Follett Corp. constantly strives to improve product quality through continuous improvement initiatives. Recently, the control board for the Maestro 400 lb. icemaker has been updated. This update includes a color change and a software revision. The service part number is 502331.

Fig. 1

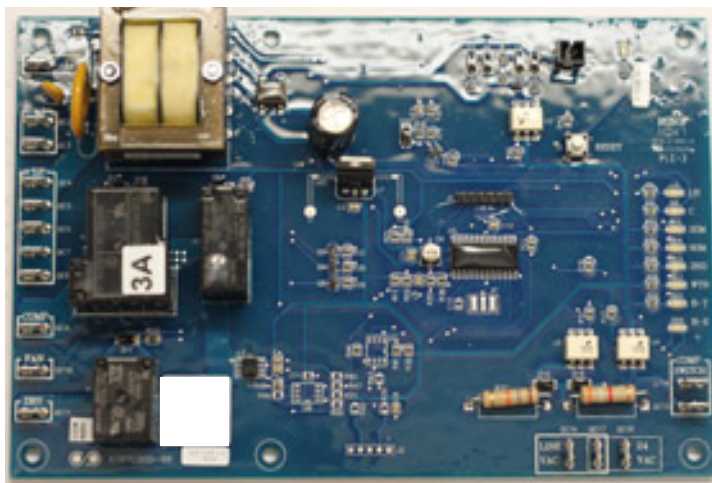
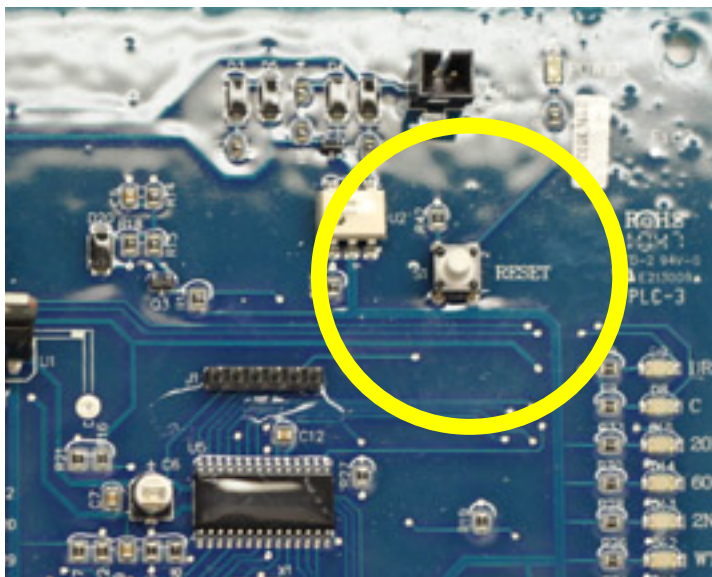
- 1. Color Change:** The control board's color has been changed from red to blue. The blue board is a direct replacement for the red board and is backward compatible.
- 2. Software Revision:** The software has been revised to require a technician's reset (via the reset button on the board) after a second error (torque out). The control board can no longer be reset by unplugging the icemaker. This prevents frequent power resets without the technician's consent, which could result in damage to the icemaker.
